Access Compliance Report

Public Rights-of-Way

(Curb Ramps)

Intersection ID: 32079	Main Street: ASHGROVE LN	Cross Street: KEEGAN WY	Location:	E
ADA ID: 88F00560EAC6	Ramp Type: PerpDiag	Initial Pass/Fail: Fail	Overall Compliance: No	Severity Score: 8.75
Codes/Mitigation Info/Possible Solution		Field Measurements/Component Compliance

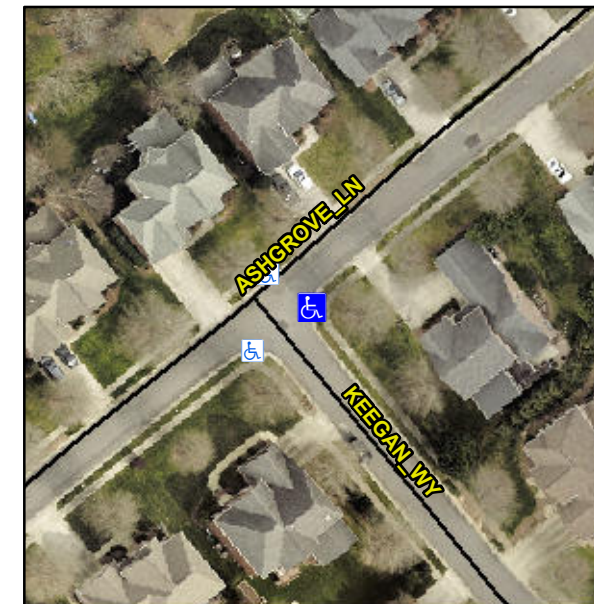
Not Found, R304.5.1

Compliance	Description	Data	Compliance	Description	Data
N/A	Ramp Length (in)	53.0	Yes	Ramp Slope (%)	5.1
No	Ramp Width (in)	36.0	Yes	Ramp XSlope (%)	0.2
N/A	Flare Type LT	N/A	N/A	Flare Type RT	N/A
N/A	Flare Slope LT (%)	N/A	N/A	Flare Slope RT (%)	N/A
N/A	Flare Traversable LT?	N/A	N/A	Flare Traversable RT?	N/A
N/A	Landing Length (in)	N/A	N/A	DWS Provided?	N/A
N/A	Landing Width (in)	N/A	N/A	DWS Contrast?	N/A
N/A	Landing Slope (%)	N/A	N/A	DWS Length (in)	N/A
N/A	Landing X Slope (%)	N/A	N/A	DWS Full Width?	N/A
N/A	Landing Curb? (Y/N)	N/A	N/A	DWS Offset (in)	N/A
N/A	Shared Landing?	N/A			
N/A	Gutter Ponding?	N/A	N/A	Gutter Slope (%)	N/A
N/A	Gutter Lip Ht (in)	N/A	N/A	Gutter X Slope (%)	N/A
N/A	Painted X Walk1?	No	N/A	Painted X Walk2?	No
	X Walk 1 Direction	To NW		X Walk 2 Direction	To SW
N/A	X Walk 1 Width (in)	N/A	N/A	X Walk 2 Width (in)	N/A
	X Walk 1 Slope (%)	5.4		X Walk 2 Slope (%)	4.1
	X Walk 1 X Slope (%)	3.3		X Walk 2 X Slope (%)	5.5

Remove & Replace Curb Ramp With Two New Directional Ramps or Equivalent.
